ARCHITECTURAL REVIEW BOARD MEETING

PROJECT COMMENTS

PROJECT NUMBER: SP2023-005
PROJECT NAME: Site Plan for the Pregnancy Resource Center
SITE ADDRESS/LOCATIONS: 1010 RIDGE RD

PROJECT NUMBER: SP2023-006
PROJECT NAME: Amended Site Plan for Stream
SITE ADDRESS/LOCATIONS: 1351 CORPORATE CROSSING

SITE PLAN BUILDING EXPANSION & LANDSCAPING
PREGNANCY RESOURCE CENTER
 1010 RIDGE ROAD
 CITY OF ROCKWALL
 ROCKWALL COUNTY, TEXAS

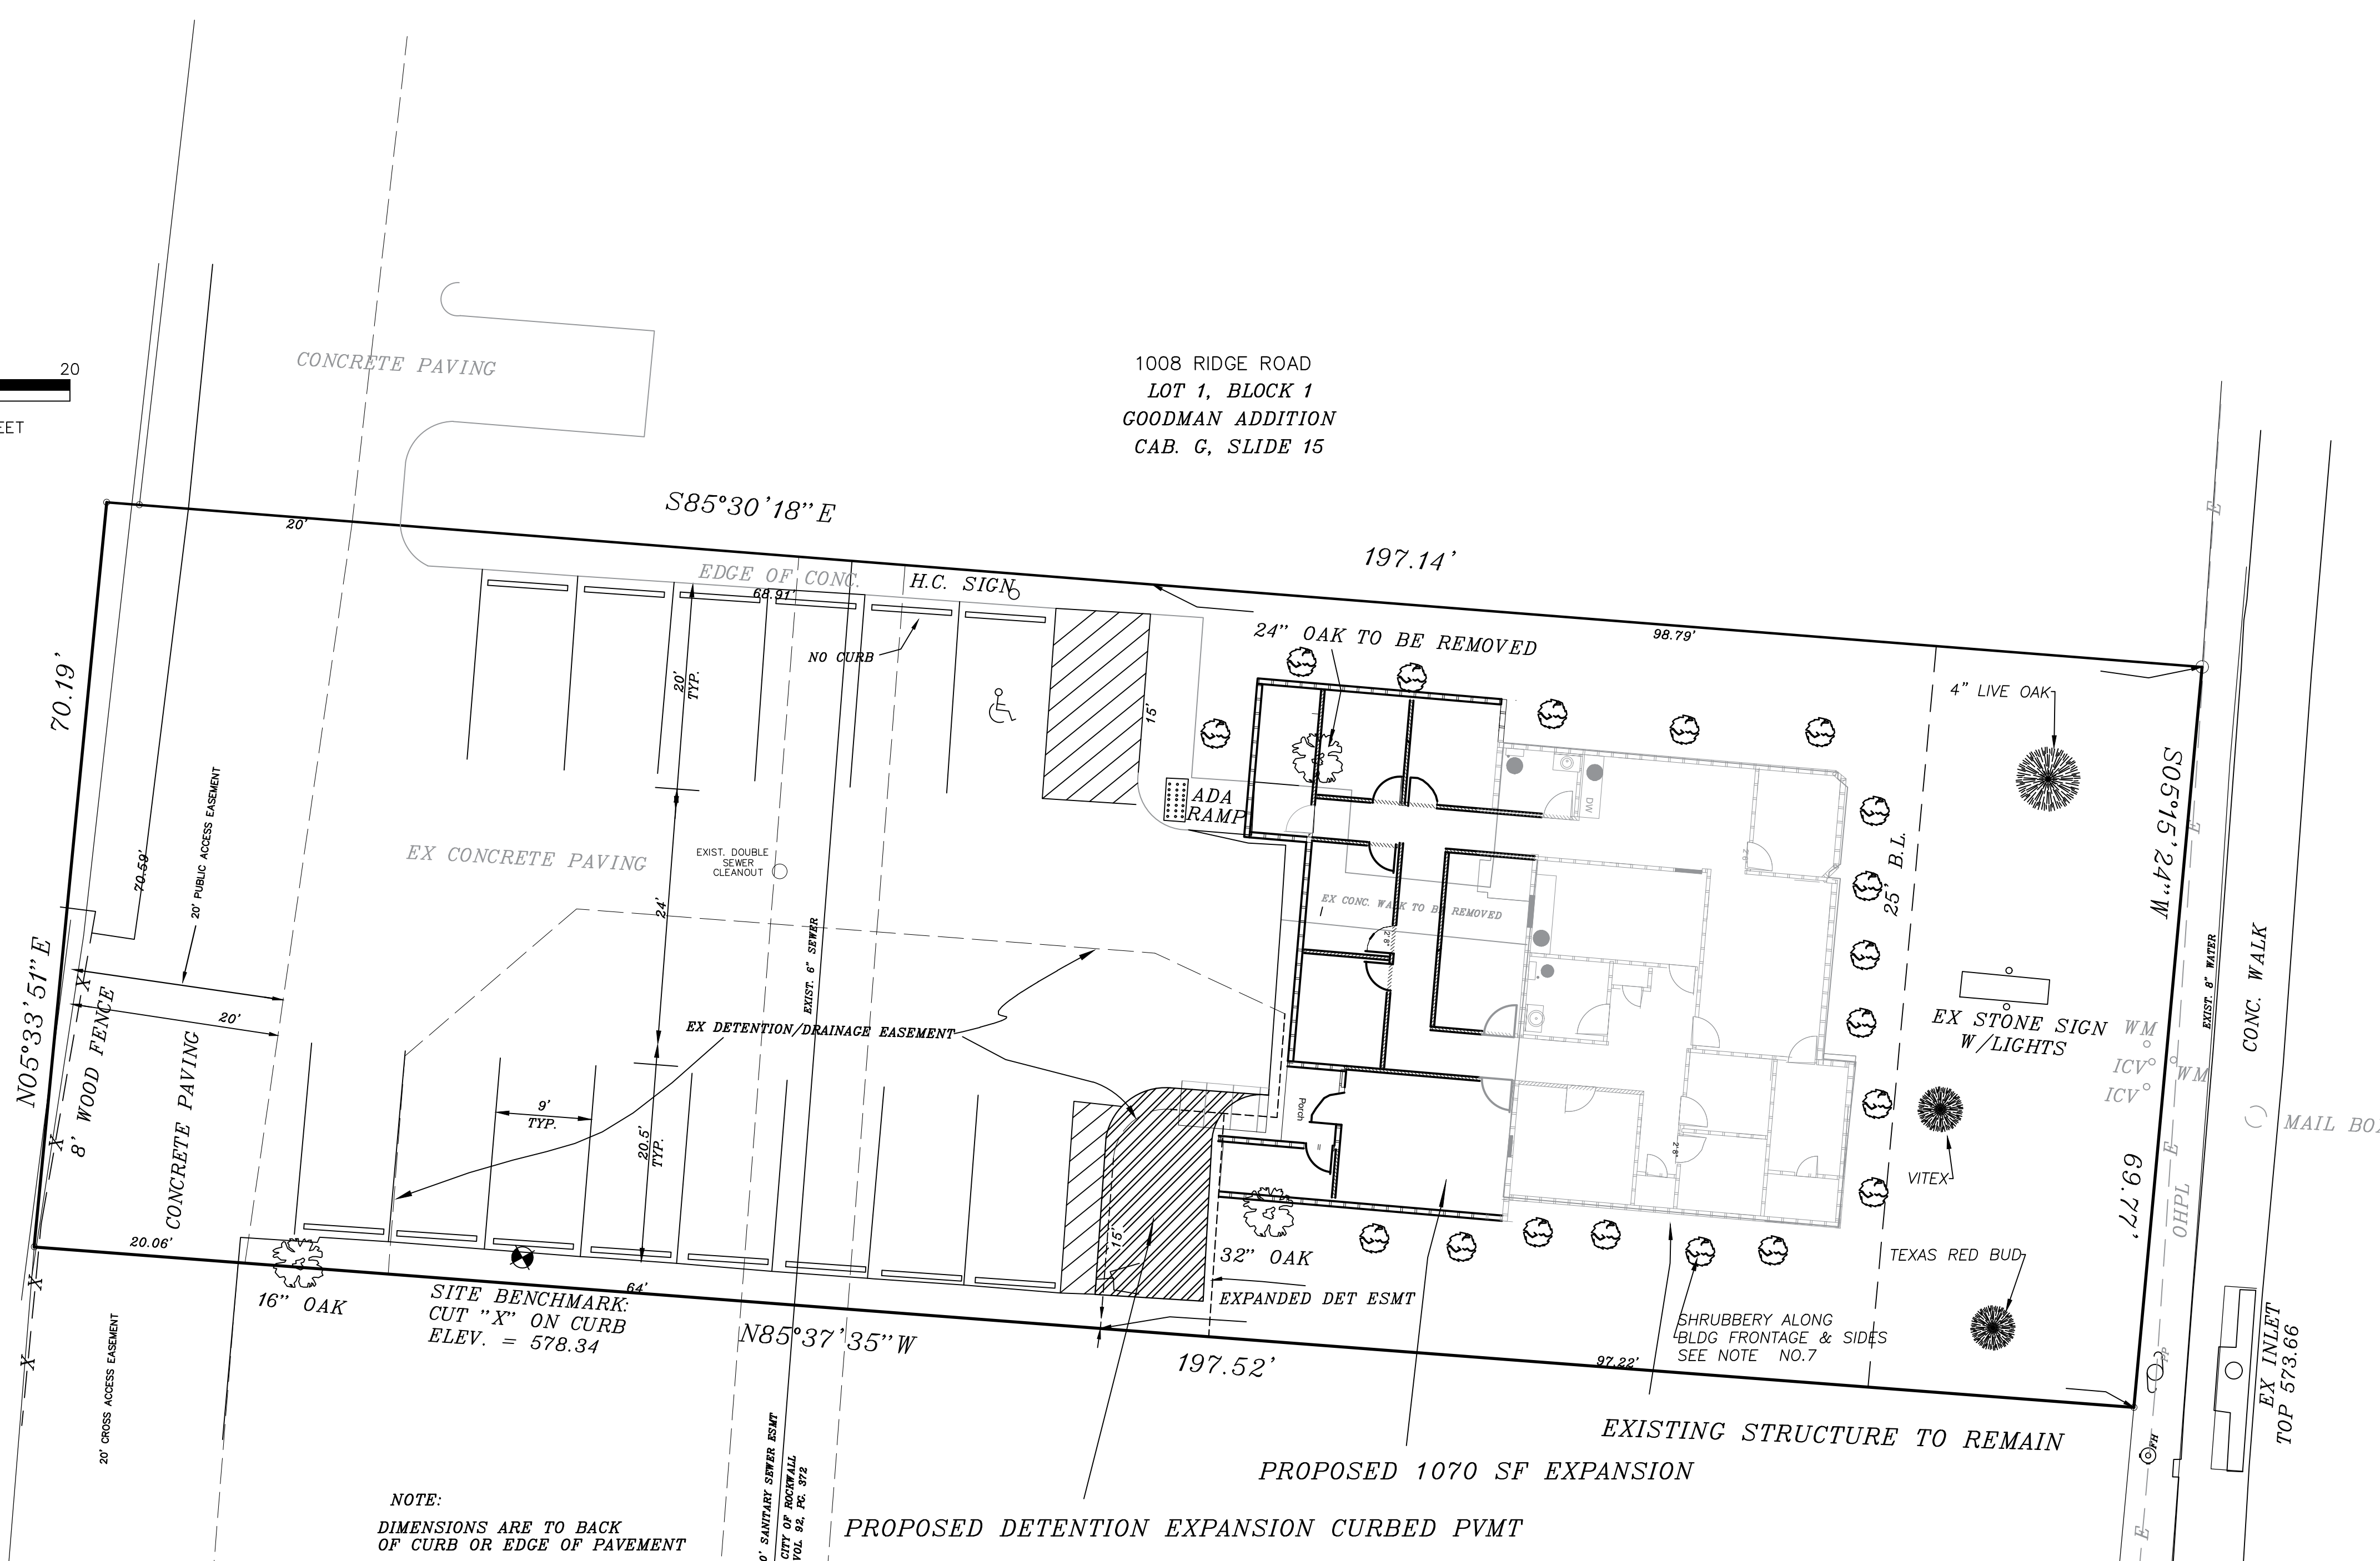
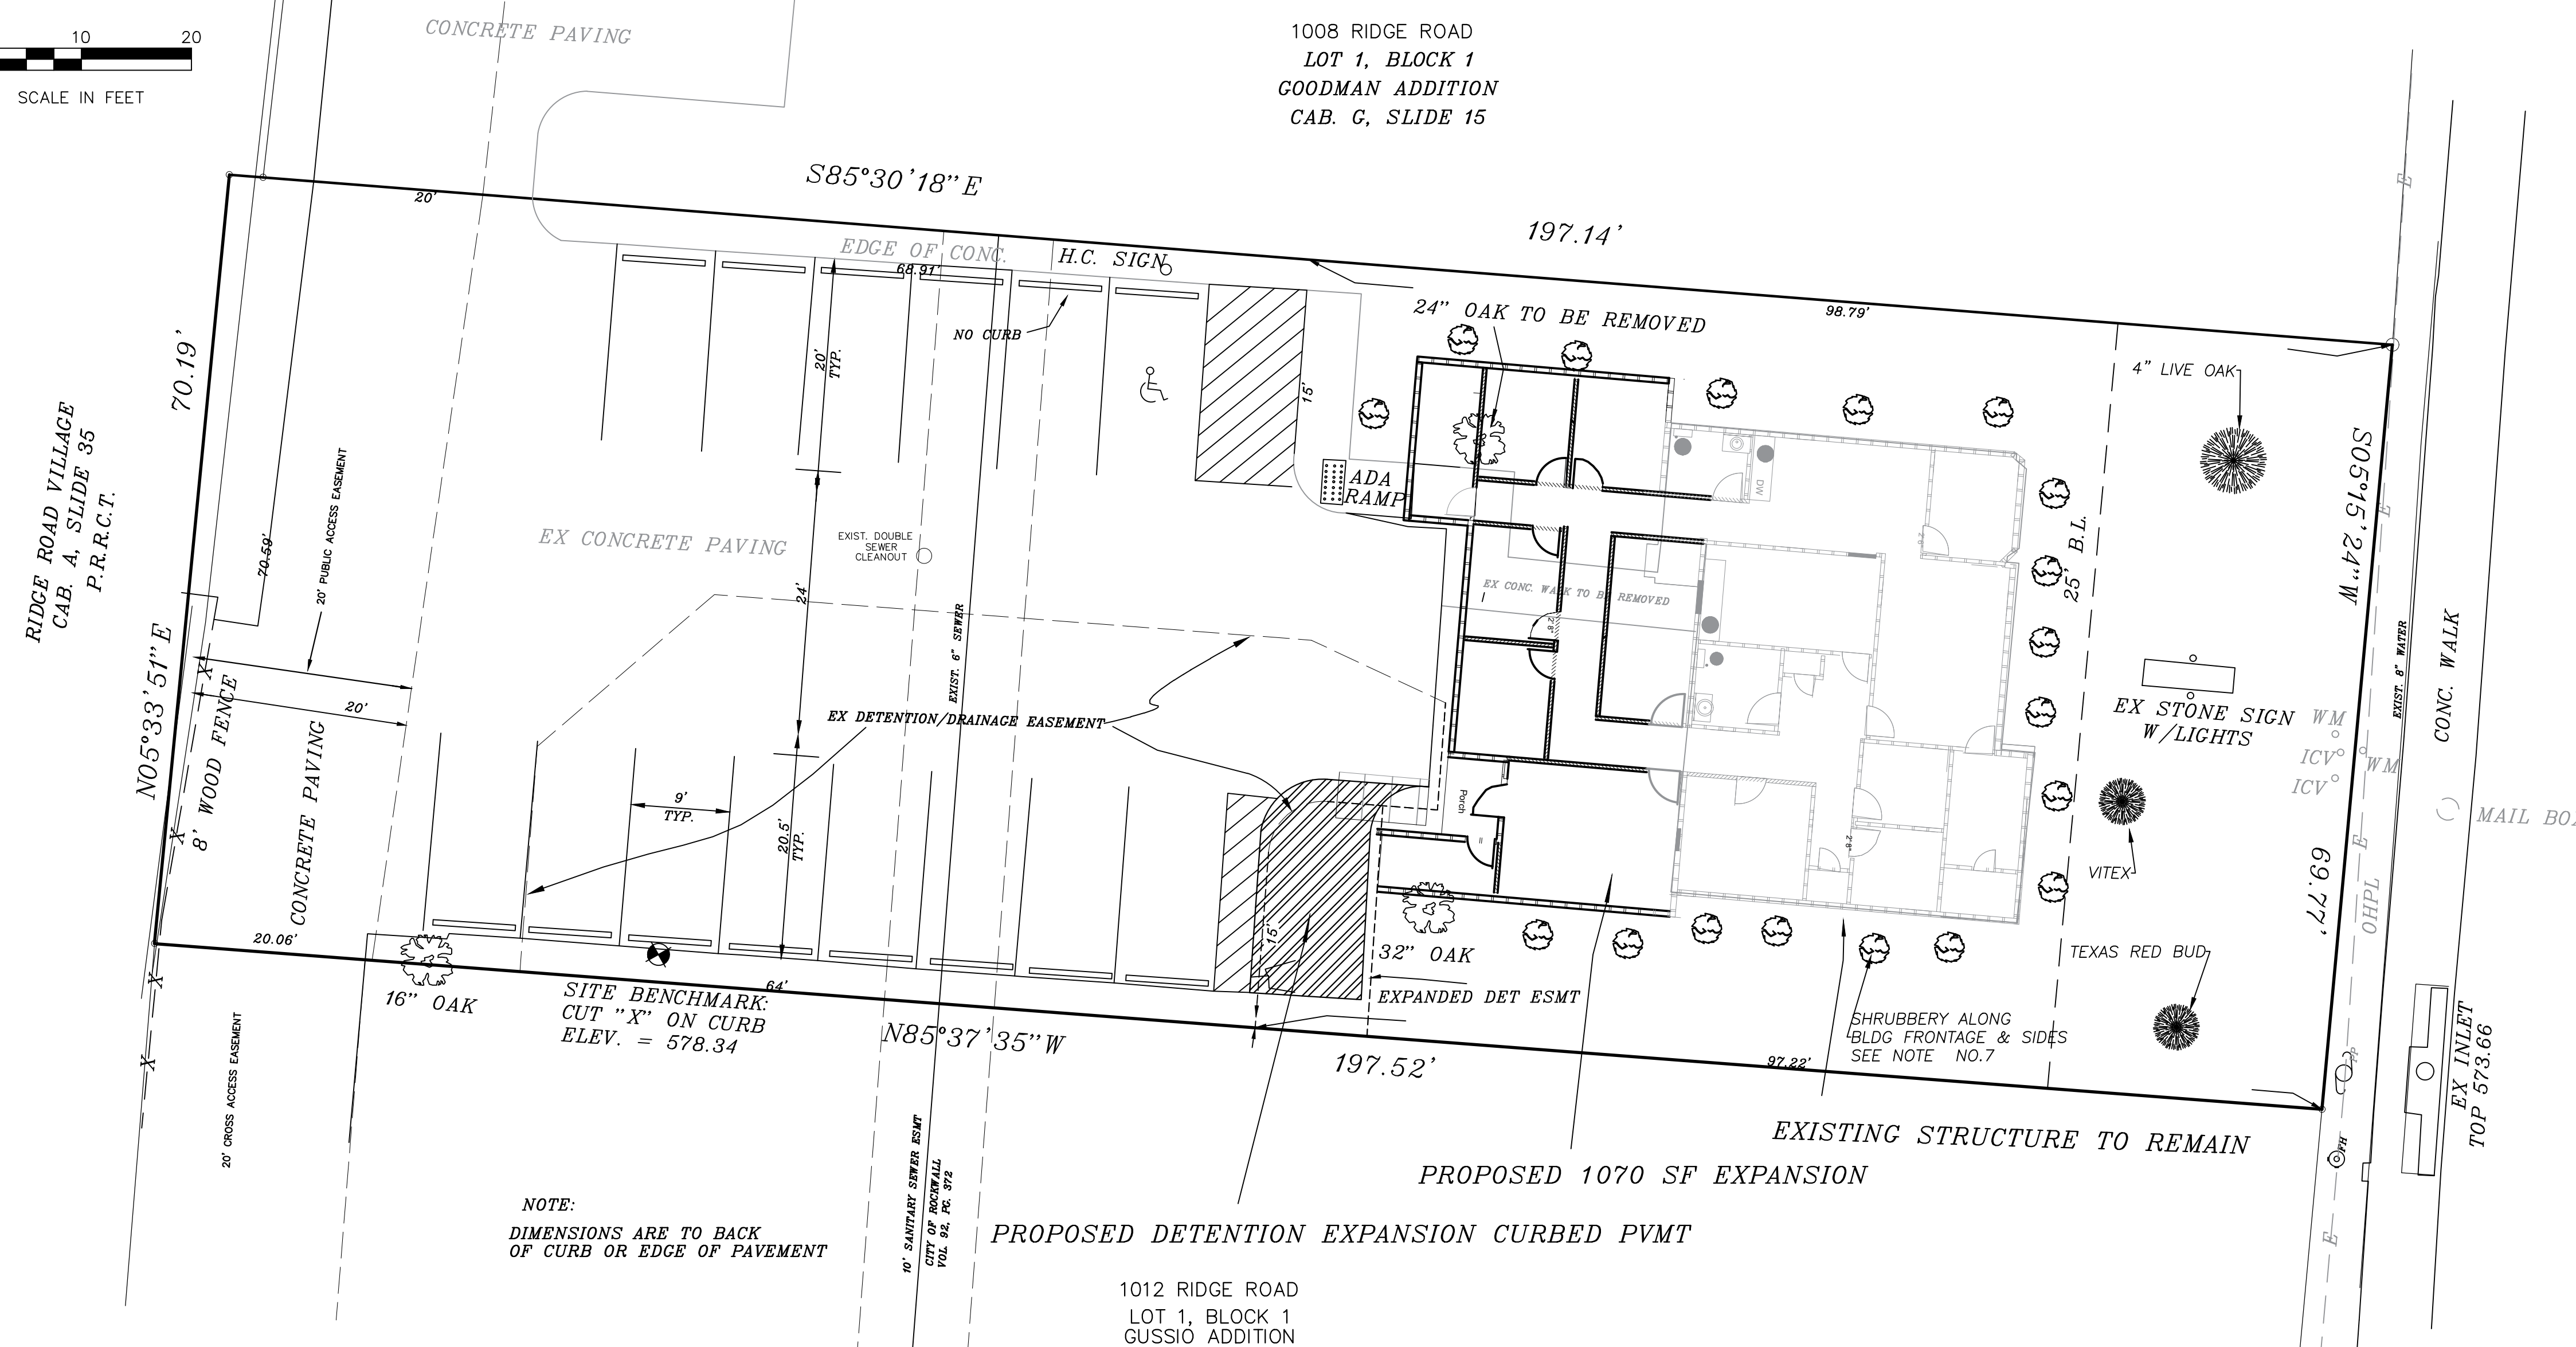
- (2) Please provide exhibits of all proposed and/or existing fencing. (Subsection 08.02, F. of Article 08)
- (3) All ground mounted utility equipment shall be screened with 5-gallon evergreen shrubs. (Subsection 01.05, C. of Article 05)

- (4) Indicate the landscape buffer. (Subsection 05.01, of Article 08)
- (5) Vitex is not an approved plant within the landscape buffer. (Appendix C)
- (6) All shrubs shall be a 5-gallon minimum. (Appendix C)

- (8) Please consider shifting the canopy trees back closer to the structure to avoid future issues with the power lines or as an alternative, consider understory trees (see comment M.5.9).

- (9) To satisfy the tree mitigation for the one (1) removed tree, consider planting one (1) additional canopy tree in the front. This would satisfy the balance; you could plant one (1) less accent tree and that would be ok. Also, consider reaching out to our Parks Director, Travis Sales, on canopy tree recommendations that do not have invasive roots and will mitigate future conflicts with the power lines. If the one (1) additional canopy tree is not planted, you will have to request approval of an Alternative Tree Mitigation Agreement from City Council (i.e. to allow you to pay more than 20% of the mitigation balance). (Subsection 03.01, G, of Article 09)

- (10) Please remove note #3, as no new lighting is being proposed.
